SUBMITTAL OF HANFORD FACILITY RESOURCE CONSERVATION AND RECOVERY
ACT (RCRA) PERMIT MODIFICATION NOTIFICATION FORM 24590-LAW-PCN-ENV-
07-005

Hanford Facility RCRA Permit Modification Notification
Form 24590-LAW-PCN-ENV-07-005

Page 2 of 2: Hanford Facility RCRA Permit, Operating Unit 10, Waste Treatment and Immobilization Plant
Update LAW Vitrification Building Process Flow Diagram - LAW Vitrification Ammonia and Secondary Offgas
System (24590-LAW-M5-V17T-P0010) in Appendix 9.1 of the Dangerous Waste Permit

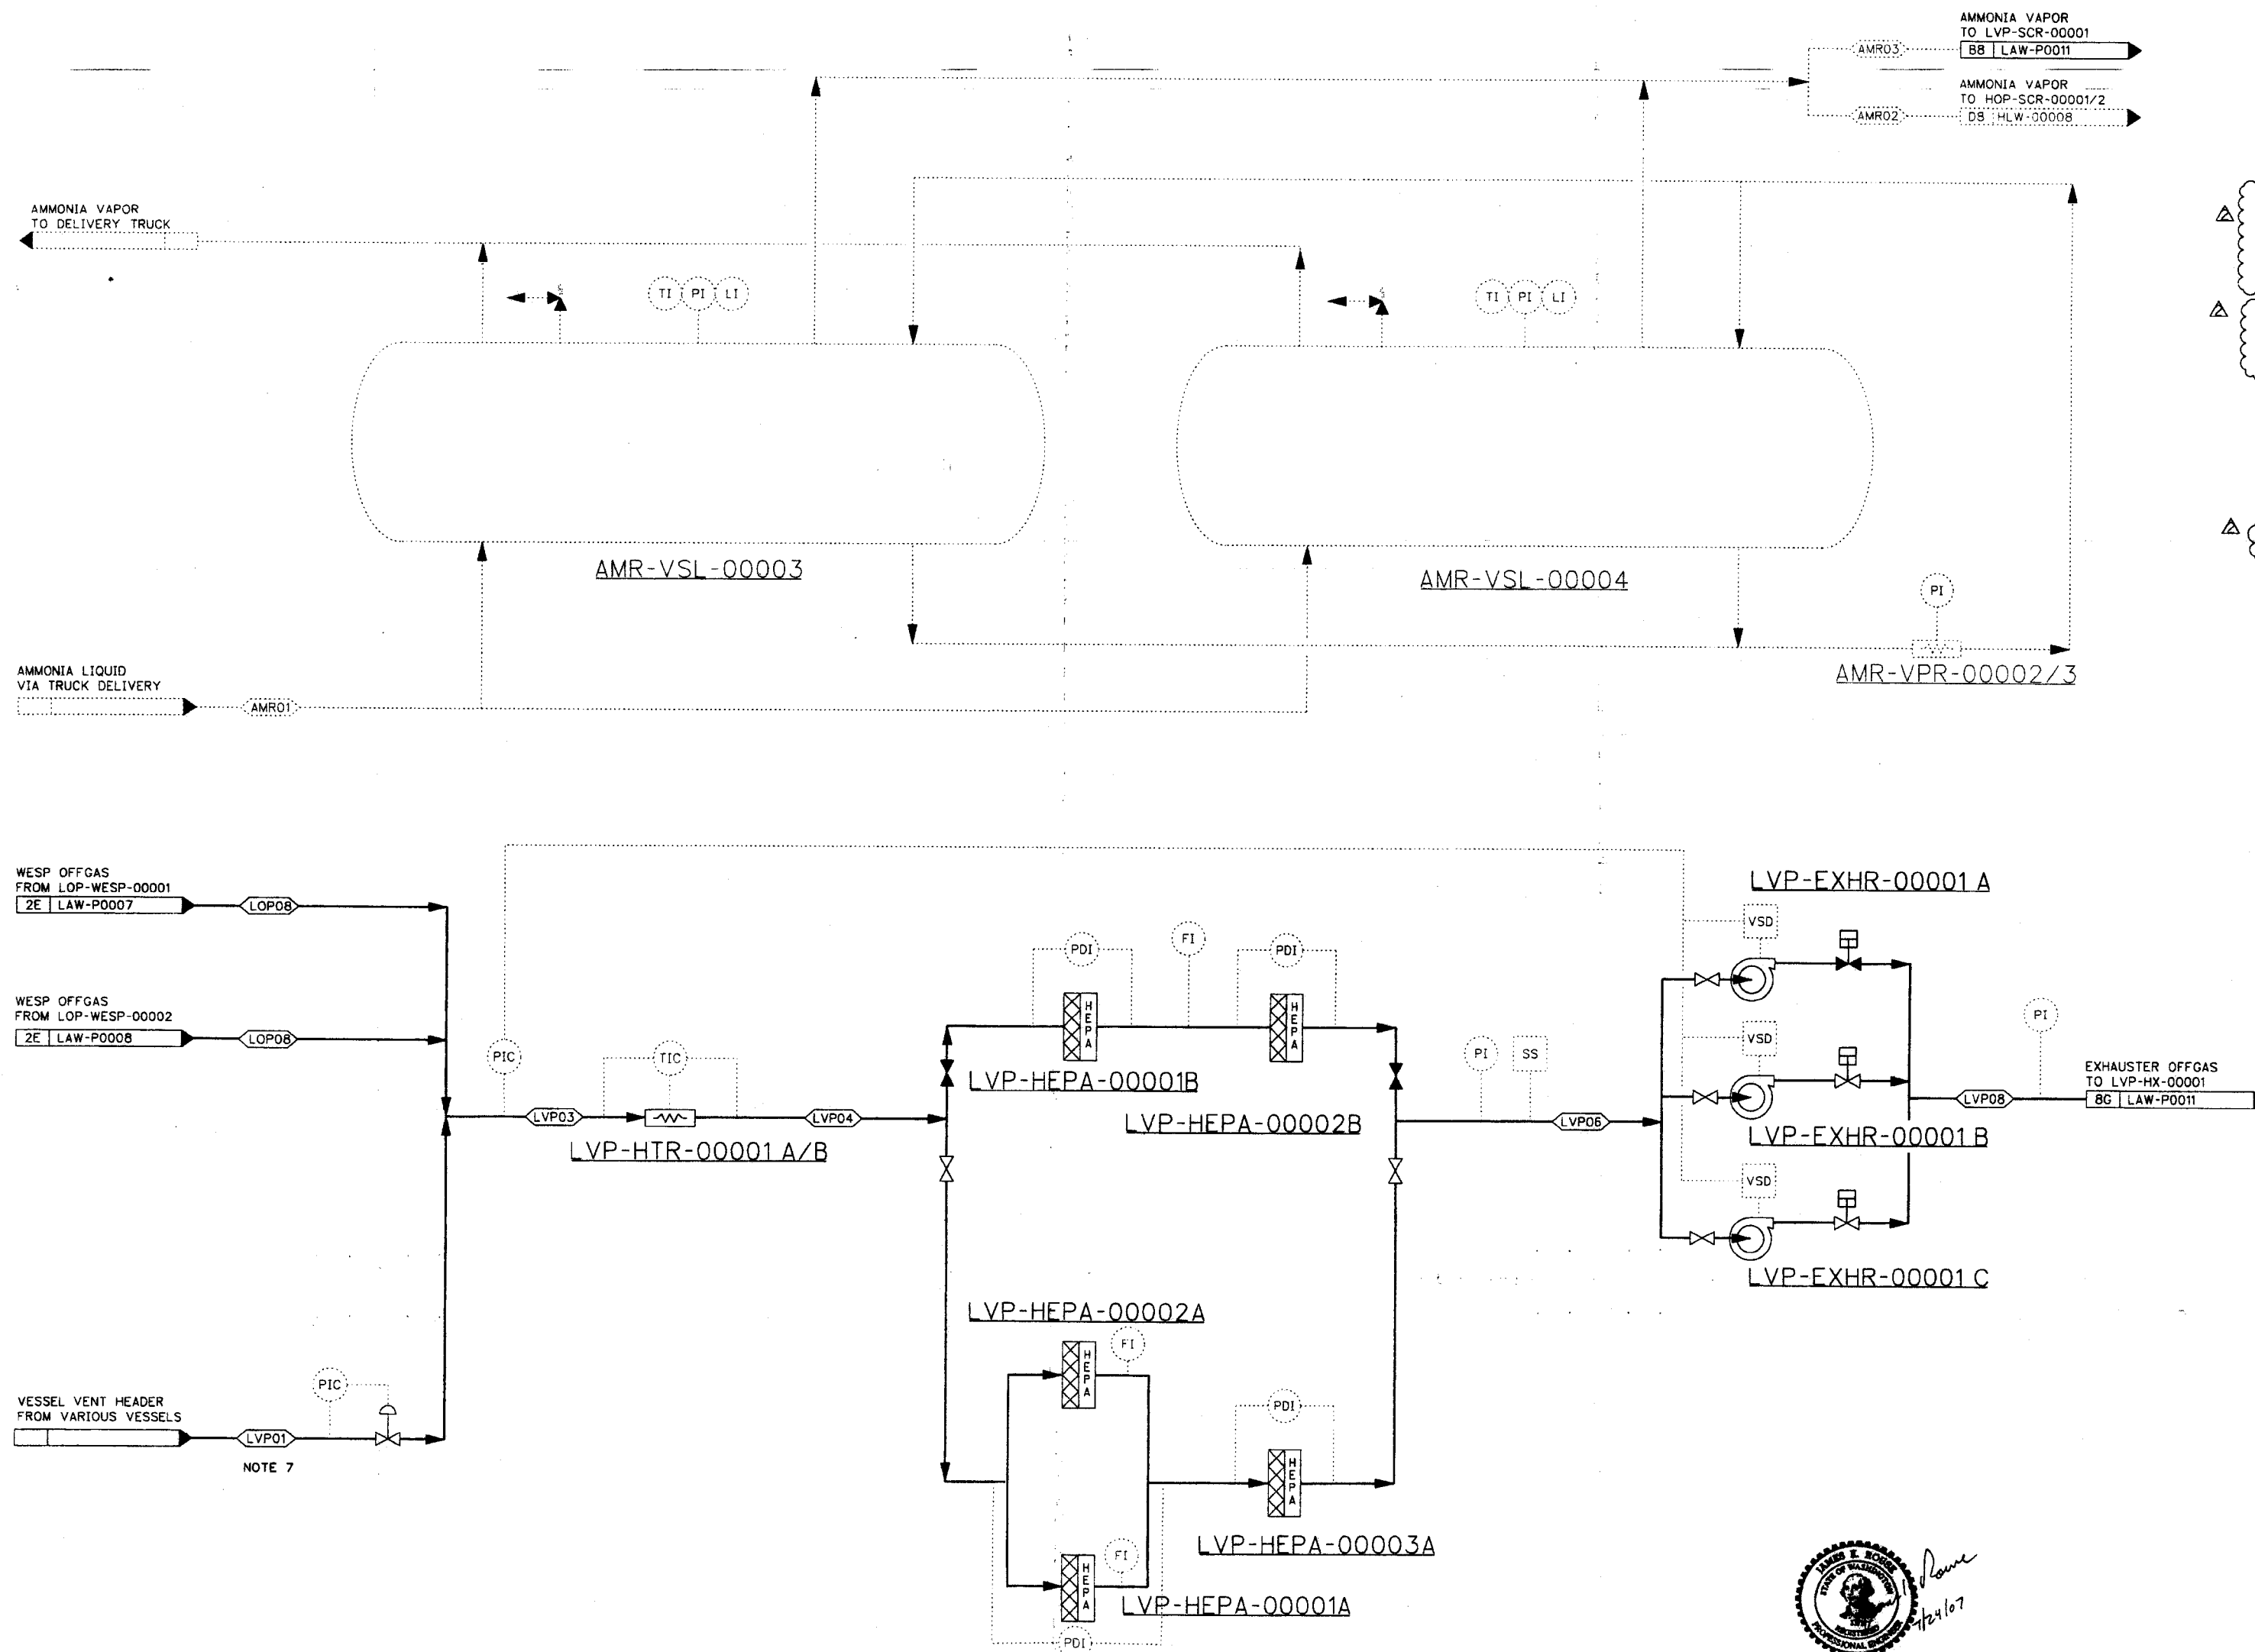
Hanford Facility RCRA Permit Modification Notification Form														
Unit: Waste Treatment and Immobilization Plant		Permit Part & Chapter: Part III, Operating Unit 10												
<u>Description of Modification:</u> The purpose of this Class 1 modification is to update the Process Flow (PFD) for the LAW Ammonia and Secondary Offgas System (24590-LAW-M5-V17T-P0010). The following permit PFD is being submitted to replace the PFD currently in Appendix 9.1.														
<table border="1" style="width: 100%; border-collapse: collapse;"> <tr> <td colspan="4" style="padding: 2px;">Appendix 9.1</td> </tr> <tr> <td style="width: 15%; padding: 2px;">Replace:</td> <td style="width: 35%; padding: 2px;">24590-LAW-M5-V17T-P0010, Rev. 0</td> <td style="width: 15%; padding: 2px;">With:</td> <td style="width: 35%; padding: 2px;">24590-LAW-M5-V17T-P0010, Rev. 2</td> </tr> </table>					Appendix 9.1				Replace:	24590-LAW-M5-V17T-P0010, Rev. 0	With:	24590-LAW-M5-V17T-P0010, Rev. 2

Appendix 9.1														
Replace:	24590-LAW-M5-V17T-P0010, Rev. 0	With:	24590-LAW-M5-V17T-P0010, Rev. 2											
The referenced PFD is a complete revisions. It incorporates changes provided in applicable document change forms (e.g., DCN, SCN, SDDR, FCN, FCR, etc.) and changes associated with the resolution to comments on change documents since the issuance of the last revision of the permitted drawing. This modification requests Ecology approval and incorporation into the permit, the specific changes to these P&IDs that are indicated by note 14, clouds, and revision triangles. Revisions are the result of ongoing design changes. The following identifies the significant types of changes on the attached drawings.														
<ul style="list-style-type: none"> Revised numbering and nomenclature for Ammonia Product Storage Vessels (AMR) throughout the drawing Corrected document number for "Process Flow Diagram Legend and Symbols" in the References section. Added flow indicators to the HEPA configuration. Revised numbering of LAW Secondary Offgas Vessel Vent Process System (LVP) HEPA filters. Revised offsheet connector labels Revised ammonia vaporization heater plant item numbers
